Subject: FW: Status update request - Baker Hwy 180

Baker Hwy. 180, SAM-2024-00431 - wetland fill for road - Gulf Shores, Little Lagoon

Reference: Variance Request; Baker, PIN# 56379, State Highway 180, Baldwin County, AL

Re: Proposed Driveway at Mr. Byron Baker's Property

Baker Road Fill

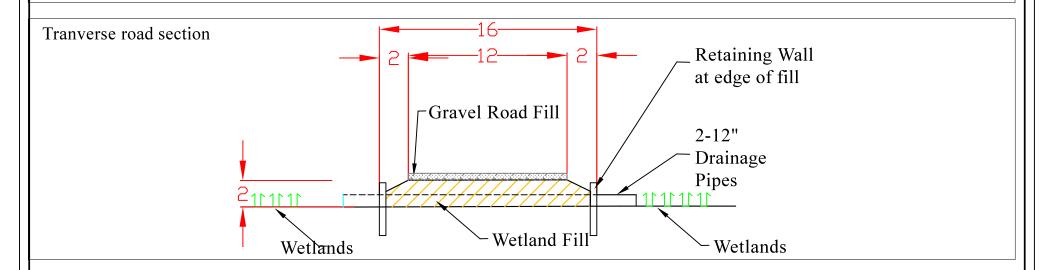
Derek and Autumn, I spoke to Mr. Baker and he agreed to use the retaining walls and that decreases the fill area down to 0.26 acres. Please review the attached drawings and let me know if you have any questions or need anything else to move forward with the permitting. Feel free to give me a call if you want to discuss.

Road Section

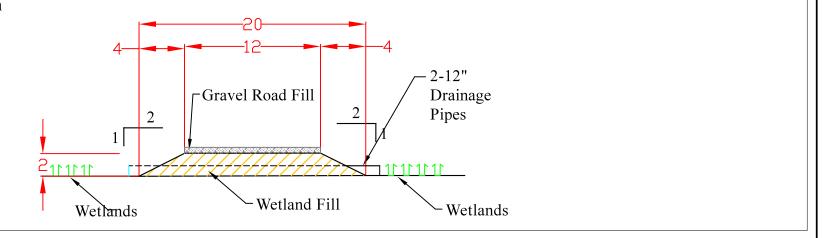
If fill is allowed, what engineering practices will be used to confine the fill to the 0.31-acre footprint? The Department will enforce compliance with the final fill design plan.

Mr. Baker has designed the access driveway to minimize the wetland impacts. The originally proposed fill area was 0.42 acres and the current proposed fill area has been decreased to 0.31 acres. Additional wetland impacts will be prevented by the placement of a Class A silt fence around the fill area during construction. The applicant has applied for a wetland fill permit from US Army Corps of Engineers (USACE) but cannot move forward with that permitting without ADEM approval of this variance request. Mitigation for the wetland fill will be accomplished through the purchase of credits in a wetland mitigation bank approved for use in the area of the project. The legal argument supporting this request is attached.
